ROHM Sensor Platform Base and Breakout Boards

Title			Sensor Platform Schematic		
Size	Document Number				Rev
B	Table of Contents/Revision History				1.0
Date:	Friday, August 01, 2014	Sheet	1	of	7

Sensor Breakout Board Interface

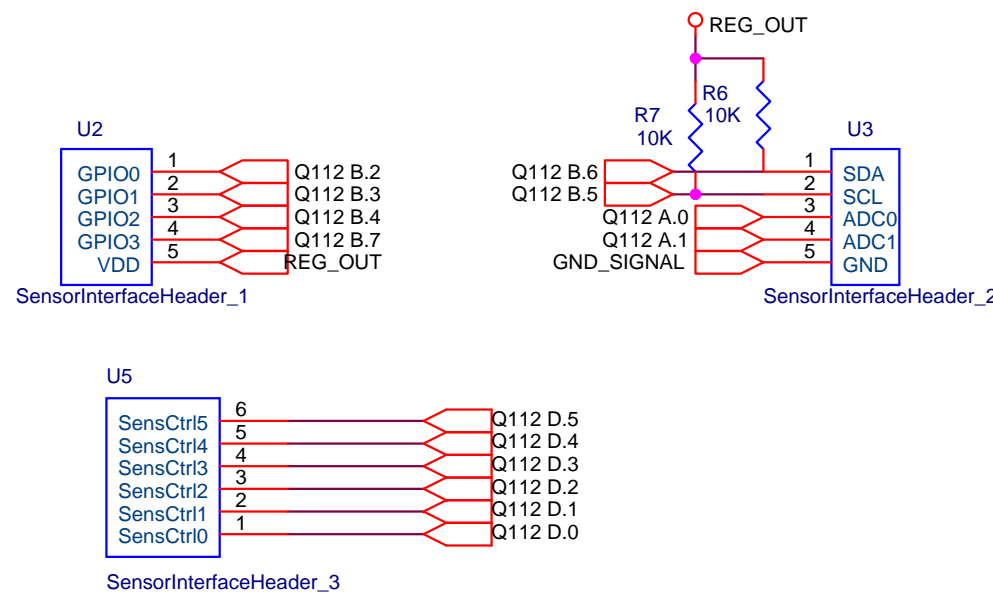
>> Header_2 needs to be a male header.
 Header_1 and Header_3 needs to be a female header.

MICROCONTROLLER DEBUGGER

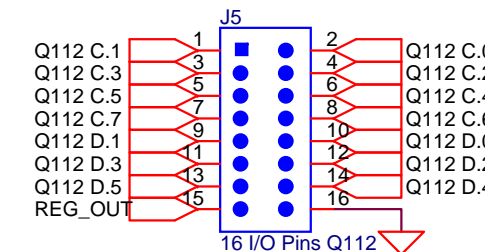
>> This should be a standard pitch 2x2 pin male header. This is a deprecated version of the debugger/programmer port. Need to build an interface cable to use our original cable

Extra Header Rows

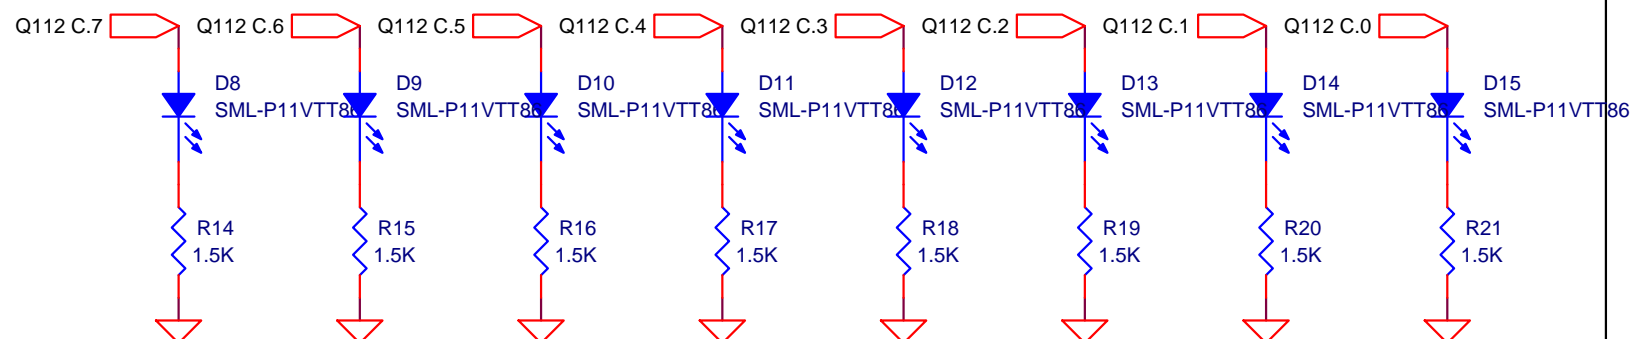
>> This does not need to be populated on a 8x2 header. These can really just be VIAS at a standard pitch. Single or Double row is OK depending on the base board module size.

Standalone Mode LED Feedback Section

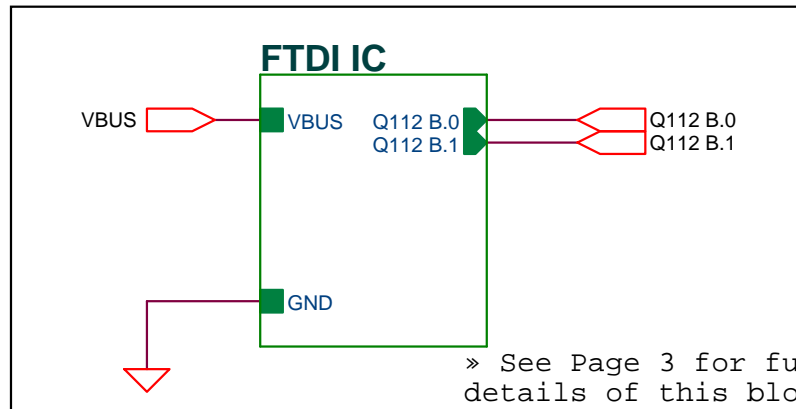
>> Using ROHM Red PicoLEDs

Ambient Light Sensors

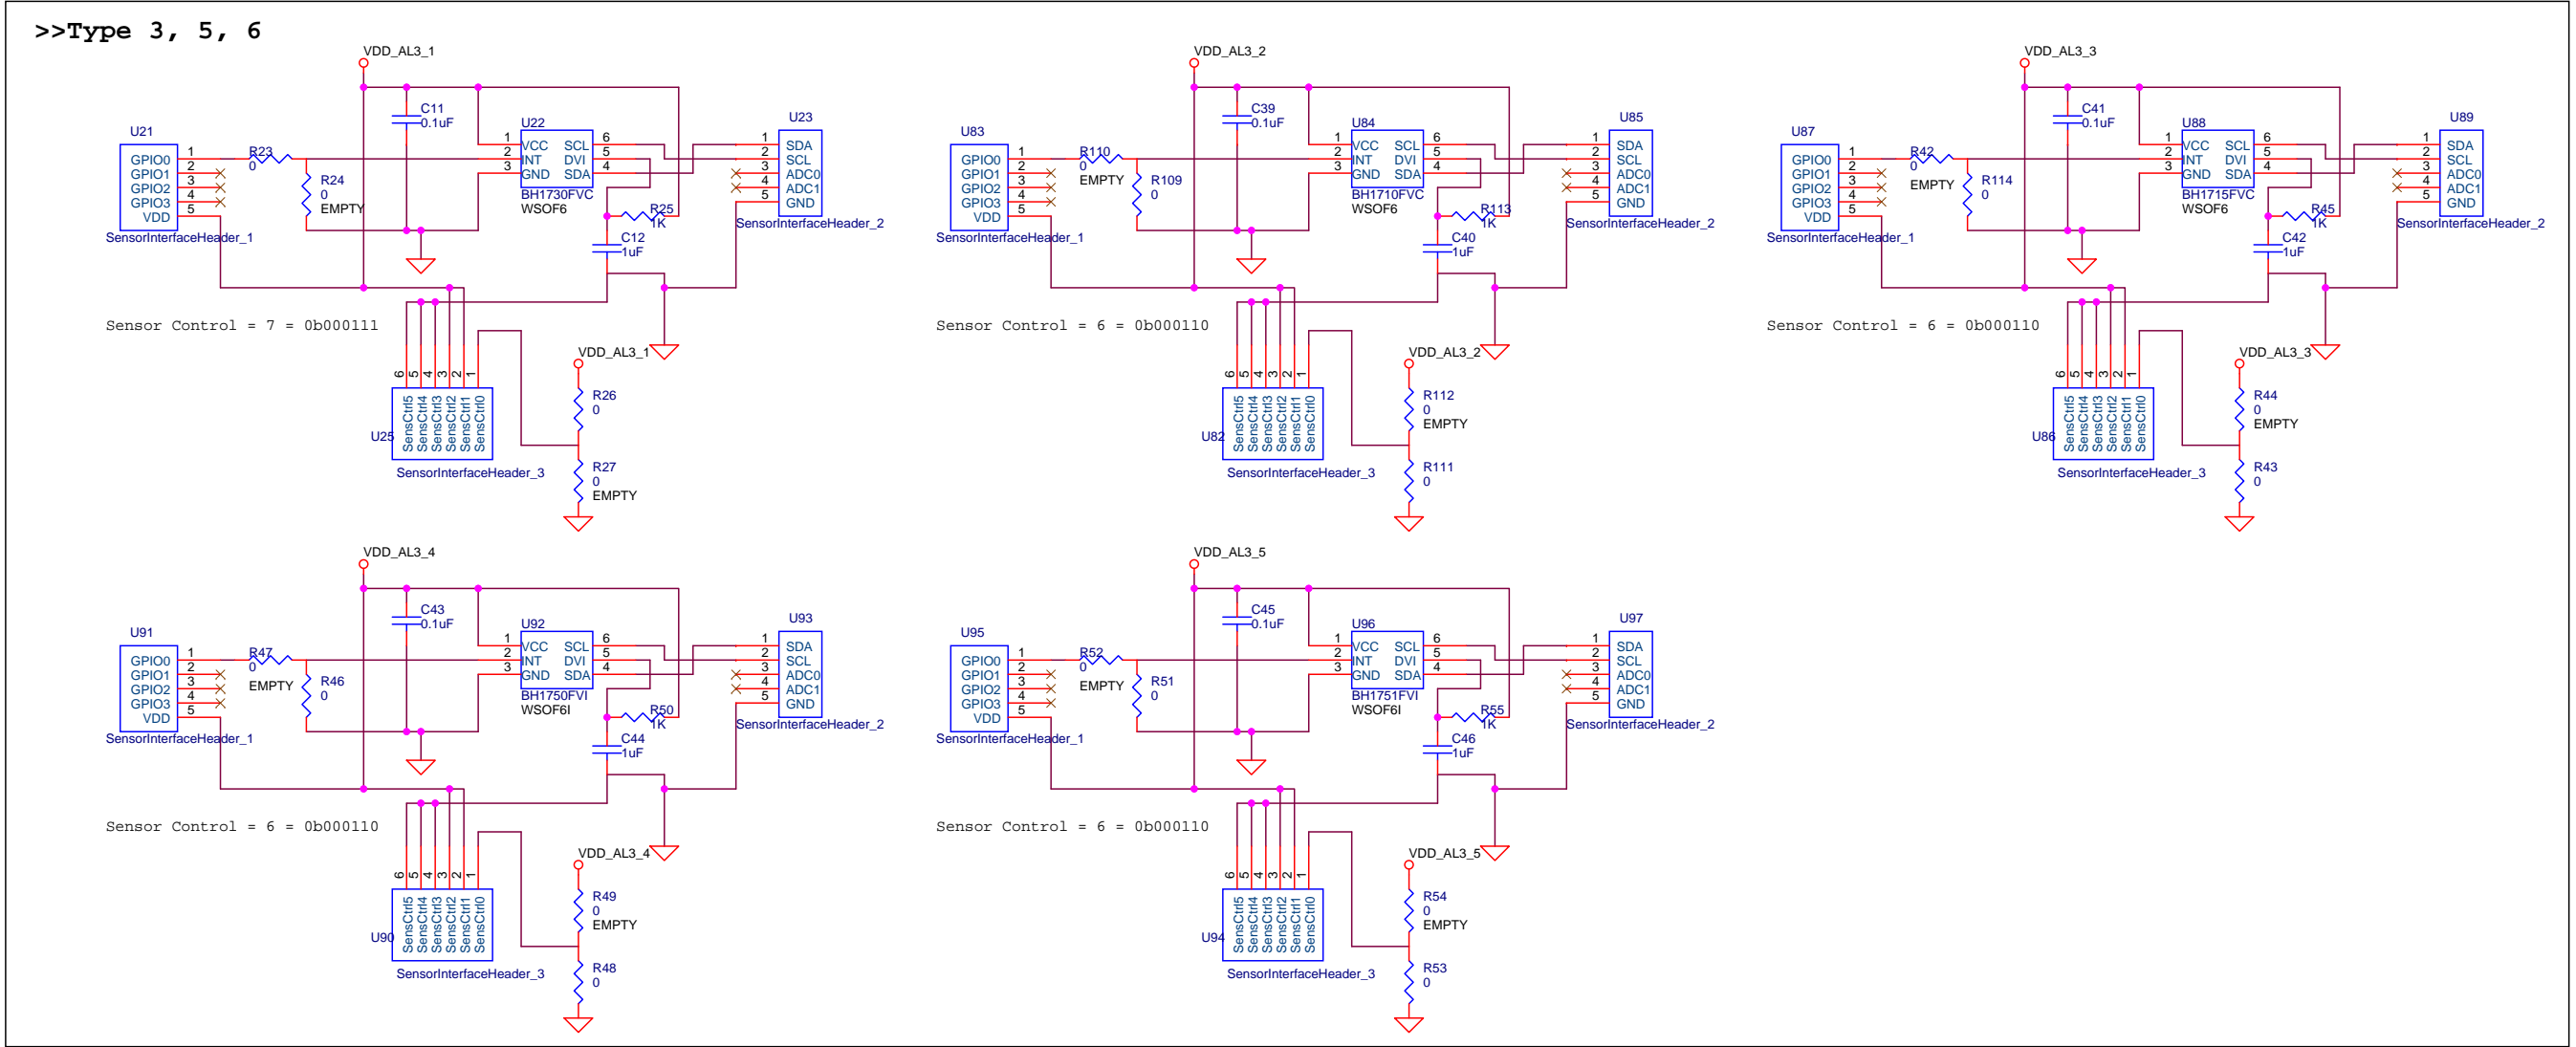
>> Header_2 needs to be a female header.
Header_1 and Header_3 needs to be male headers.

Hall Sensors

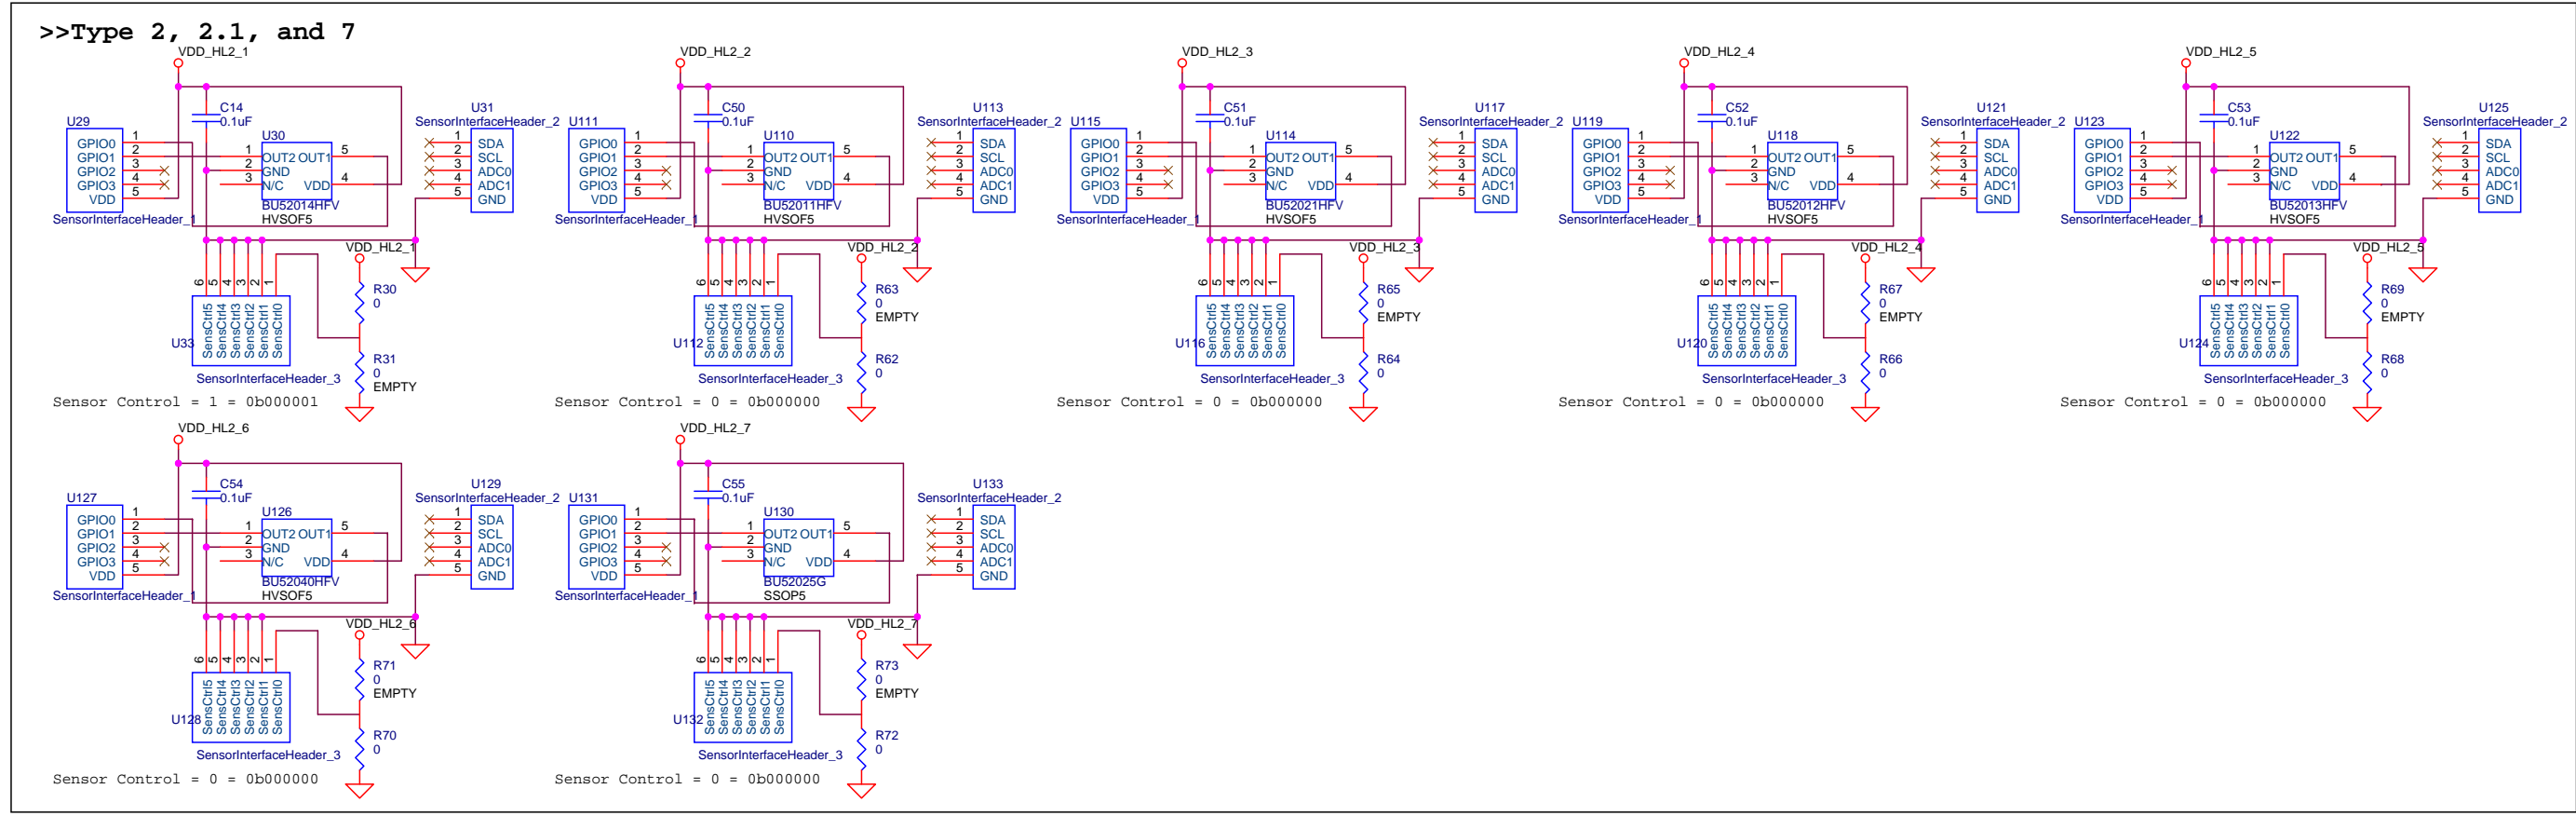
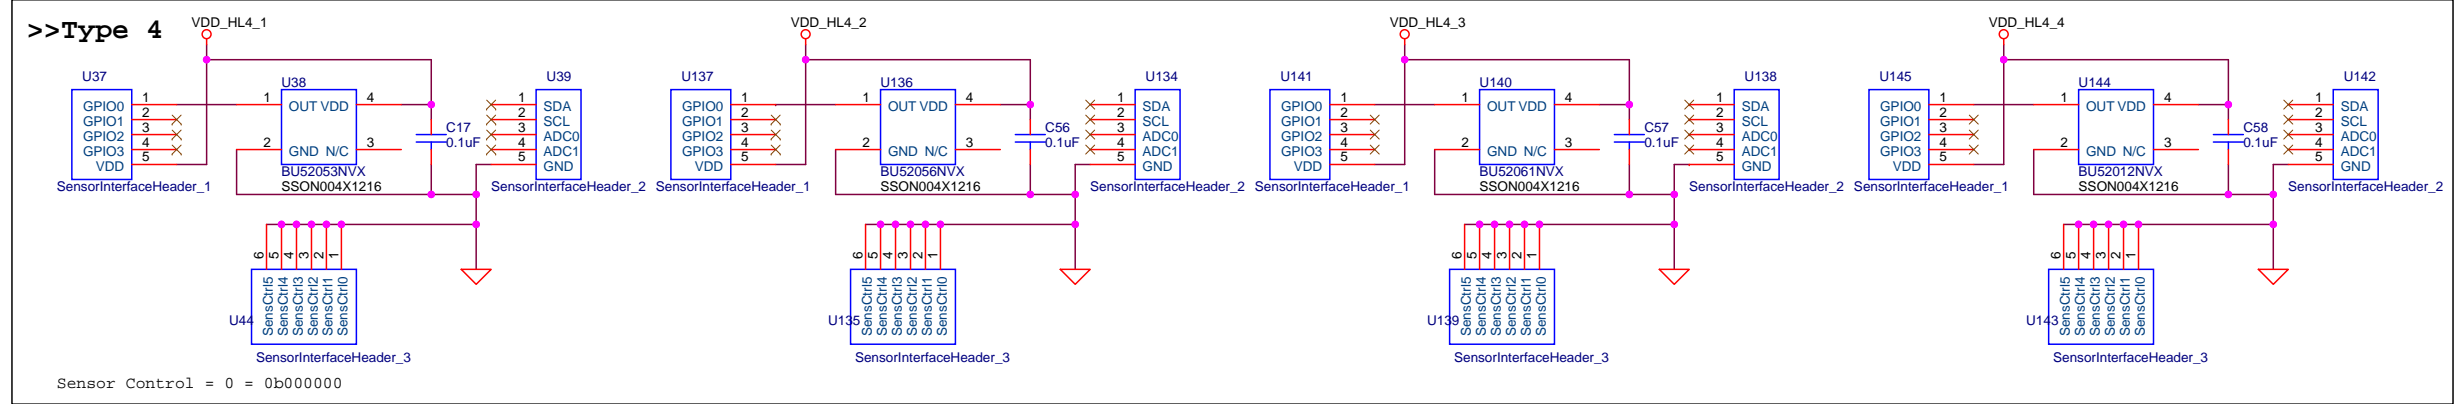
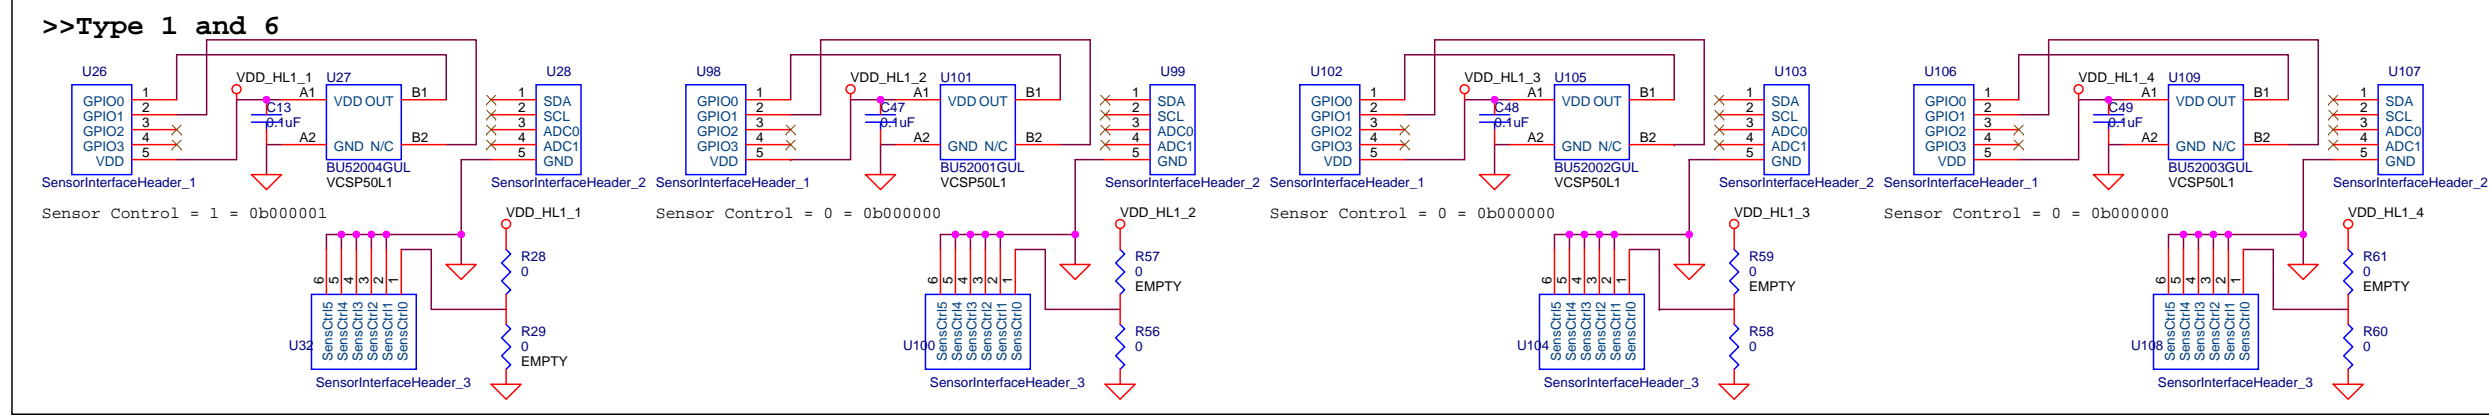
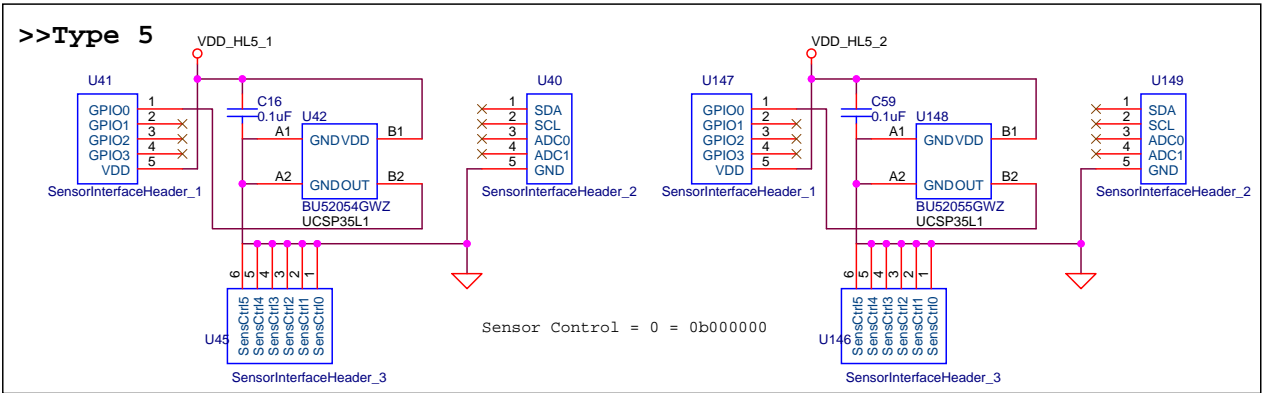
>> Header_2 needs to be a female header.
Header_1 and Header_3 needs to be male headers.
